**COLORADO STATE  
UNIVERSITY**

# Physical Development Committee

February 16, 2024 Meeting

# Request for temporary branding to be permanent

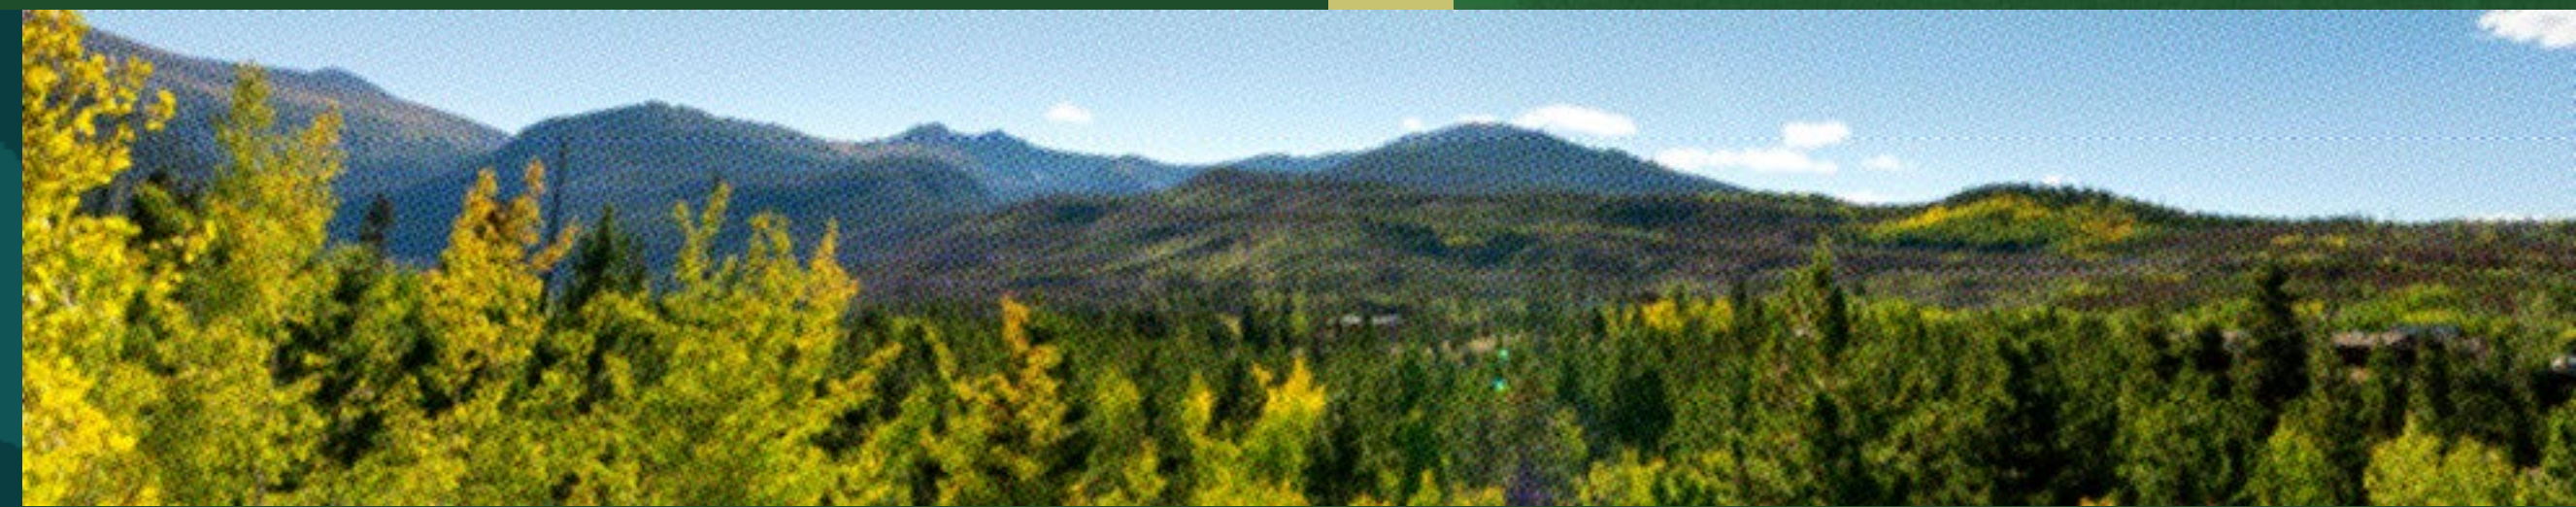
- DRC reviewed this in January, with the discussion points:
  - The DRC felt the branding film applied to the subject buildings was successful and of novel impact and appreciated the quality of the installation and initial impact.

- **Leaving the branding in place permanently was objectionable to the DRC** based on the following considerations:
    - The Student Recreation Center and LSC projects were very well received at the time of occupancy. The completed facilities were noted as award winning, signature buildings on campus where associated daylighting, views, vistas and the “lantern effect” informed the design process and resulting architectural expression. The DRC felt the buildings should be returned to their original state.

- The impact of the branding has and will continue to become less impactful over time and the application subject to degradation.
    - The longer the film is in place, the more difficult it may be to remove. Noted that the university would need to budget for the removal and rigorous cleaning of the glass.

- The film application long-term could be of impact on the energy model completed during design and the building commissioning completed during construction. Creation of, commissioning and adherence to the energy model were required by the building codes for permitting, inspections and occupancy.

- DRC recommends adherence to the original recommendation as codified by the PDC but would support an extension of the installation through the end of December 2024 as long as the film remains in good repair.
- At the end of 2024, the branding would be removed and glass cleaned prior to the start of the spring semester in January 2025.
- Suggest updated review, consideration and administration of the recommendation by and from the PDC.
